11 July 2022

Planning Permit Application TP 136/2021

Proposed Use and Development of a Place of Assembly, Outbuilding, Display of Signage, and Development of Land

Lot 1, TP164431R Mount Baimbridge Road, Hamilton 3300

1 - MAIN CARPARK

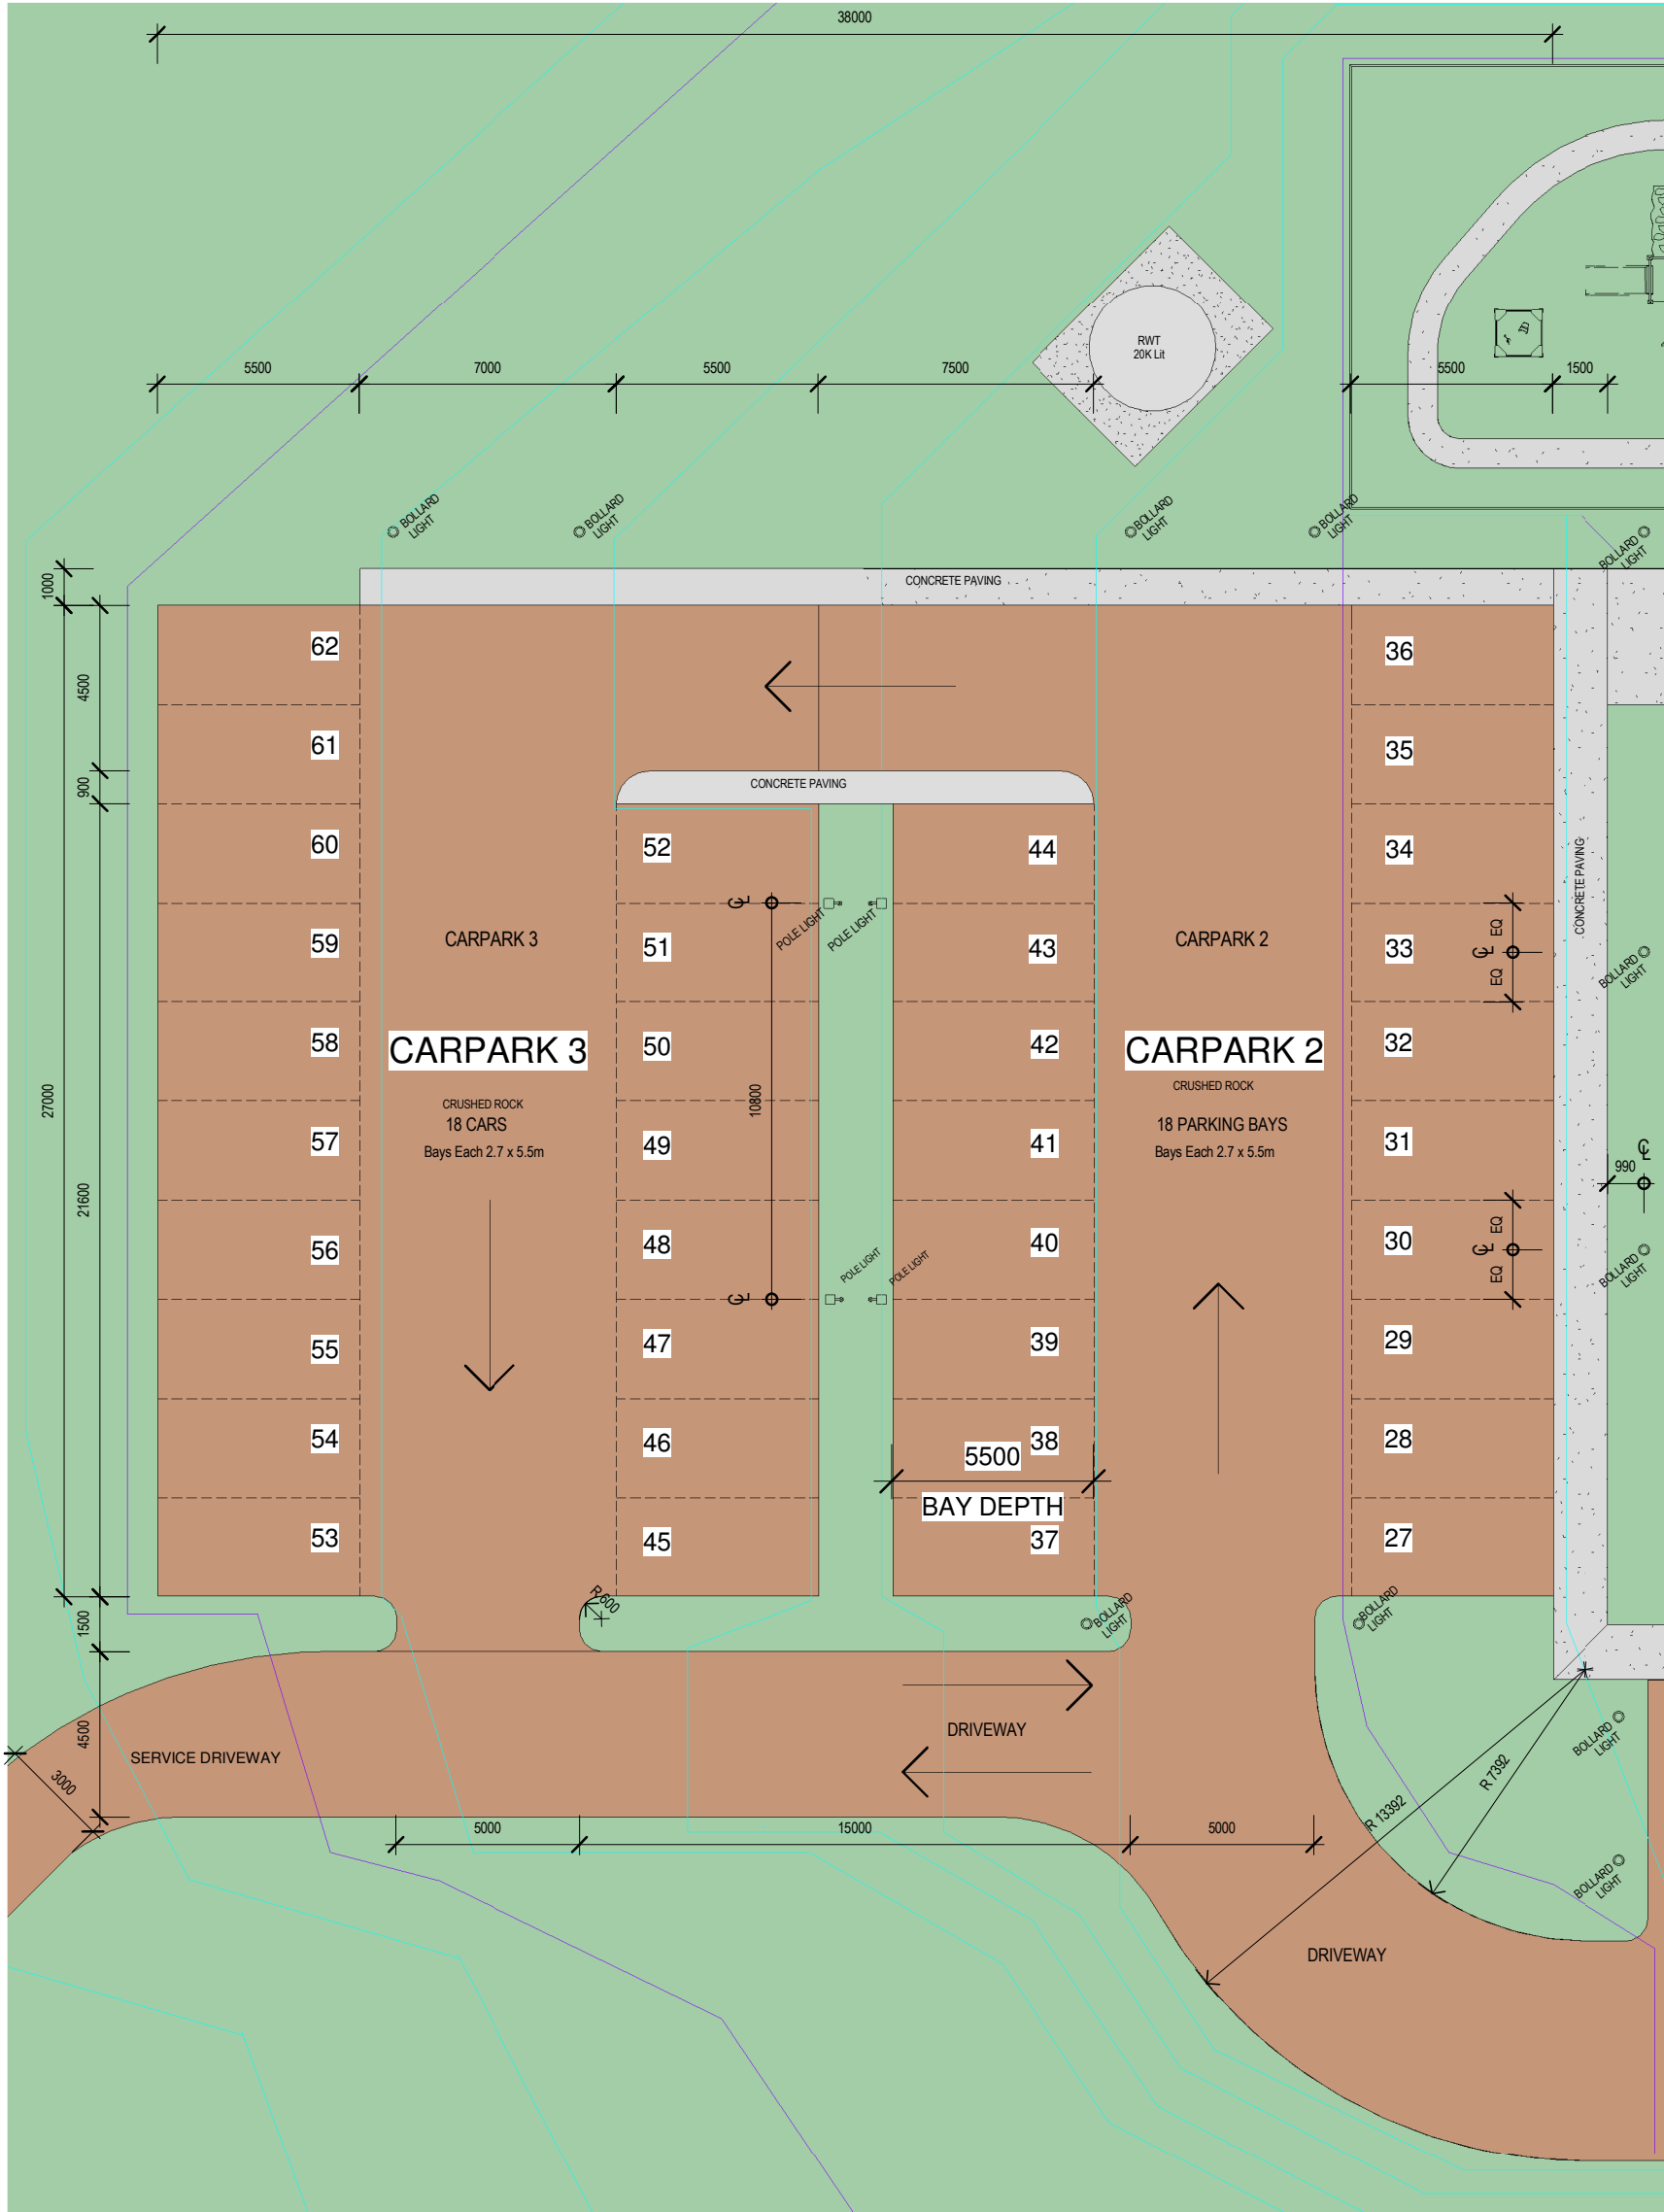
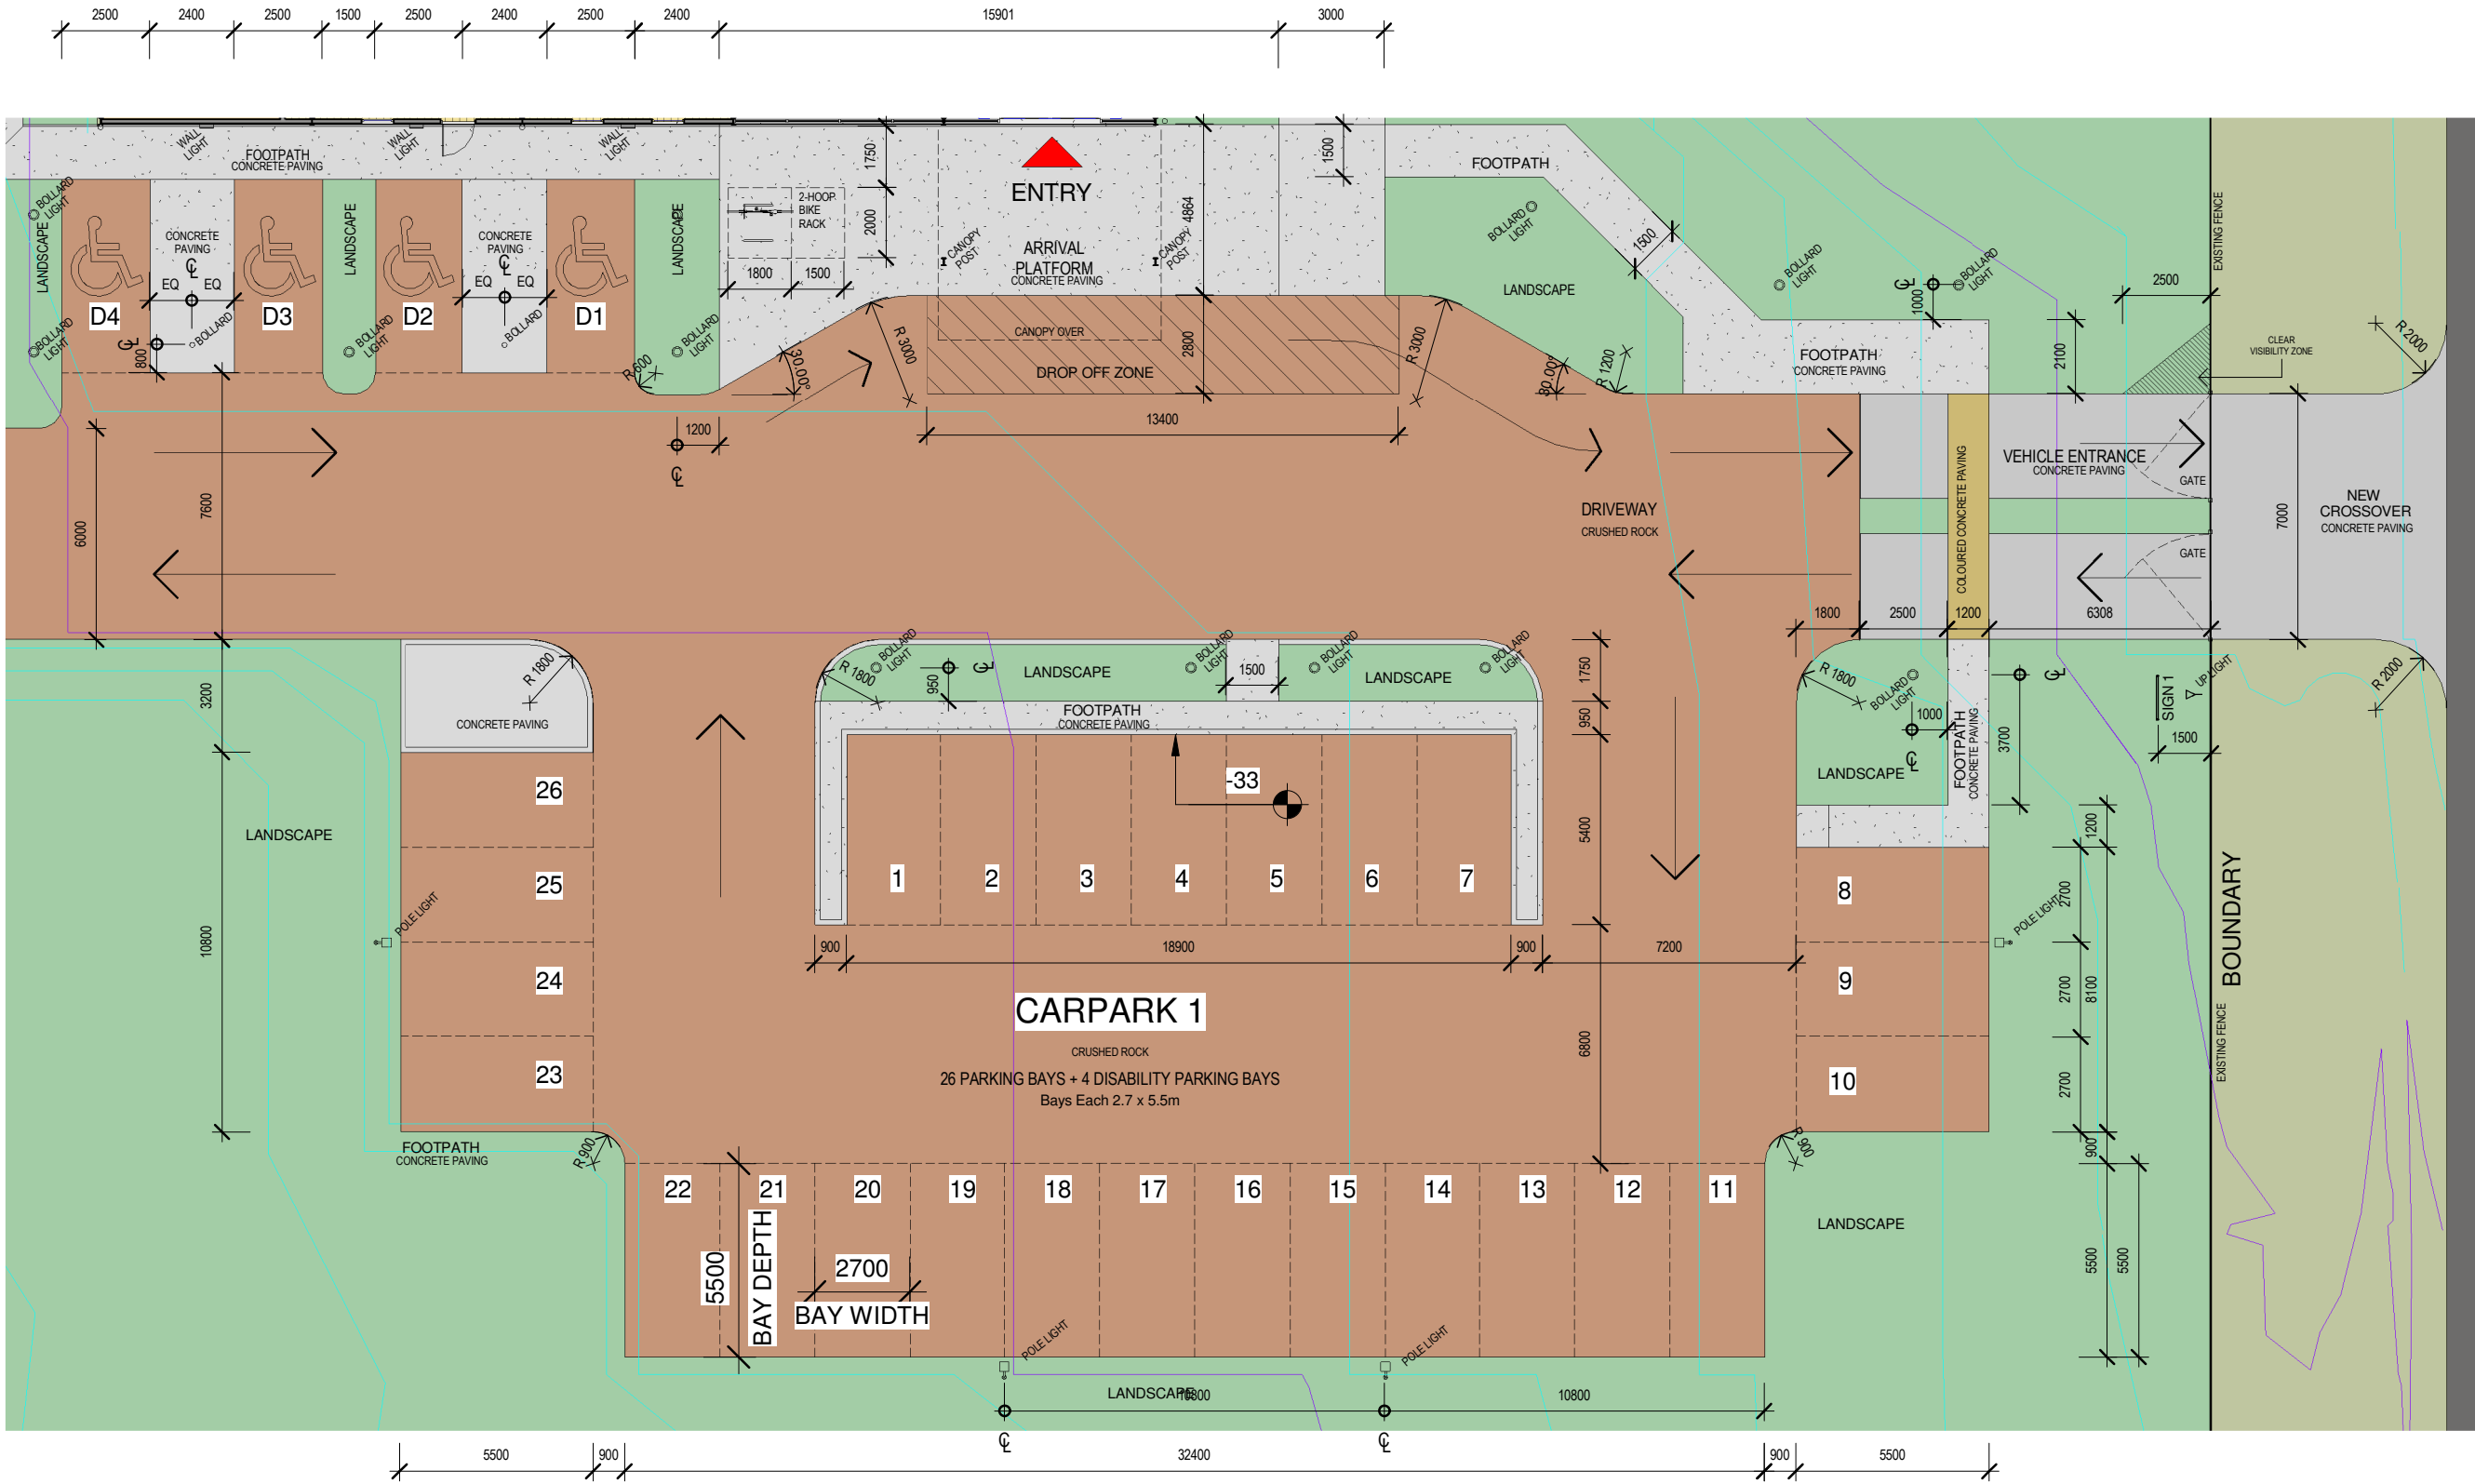
e. Provision of bicycle parking in accordance with clause 52.34 in the Planning Scheme.

c. Refer to the amended Site Plan and the amended Car Parking Plans.

Refer to the Traffic Engineering Assessment, the amended Site Plan and the amended Car Parking Plans.

Drawing
PROPOSED SIGNAGE SCHEDULE

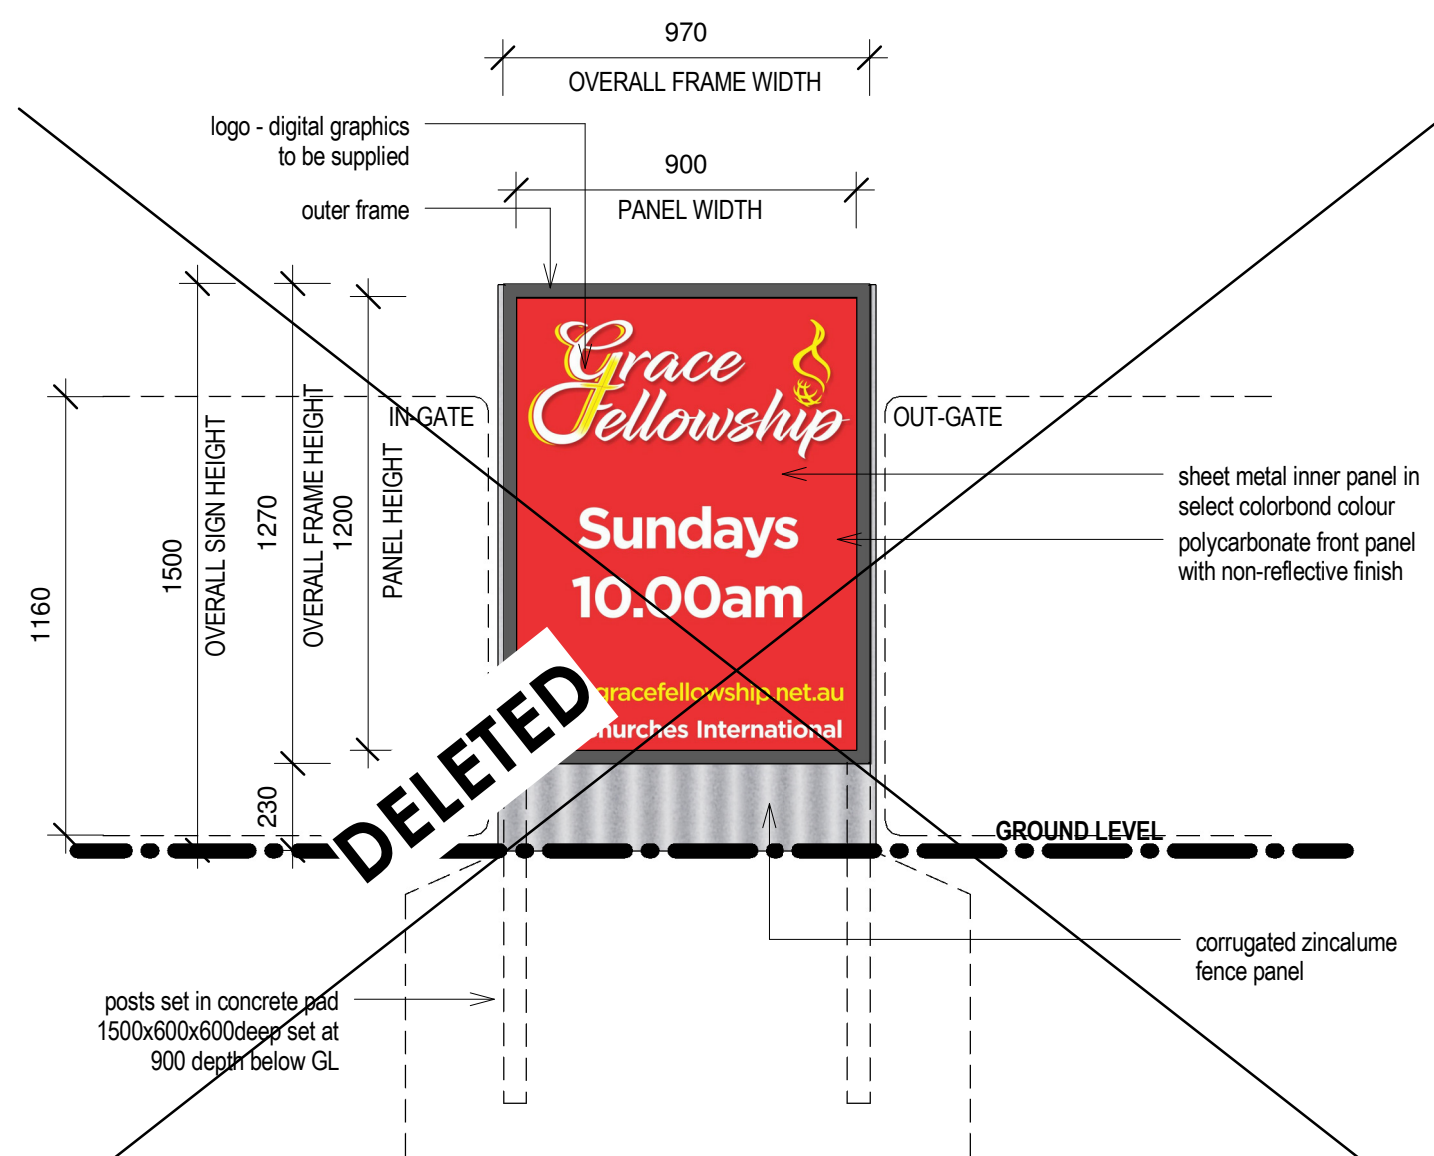
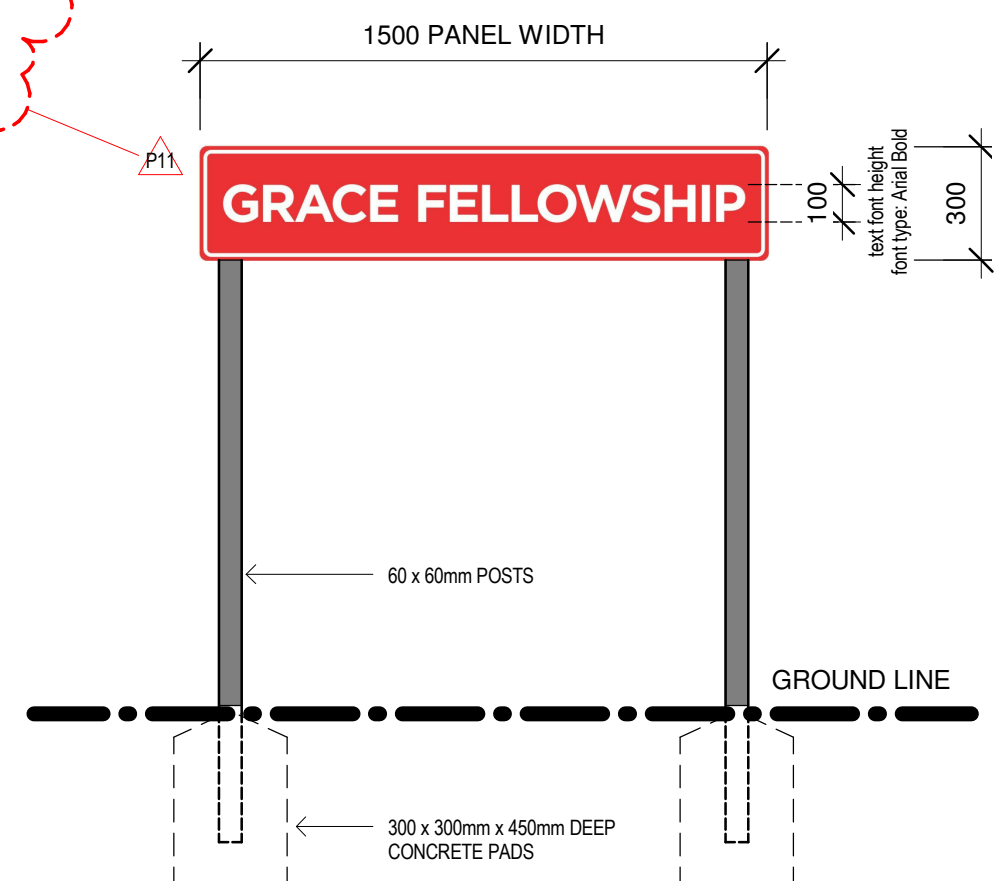
- f. Clearly show the location and details of all signage in accordance with Clause 52.05 Signs in the Planning Scheme with removal of the proposed signs 1 or 2 and 4.

- f. Refer to the revised Site Plan and the revised Signage Details.
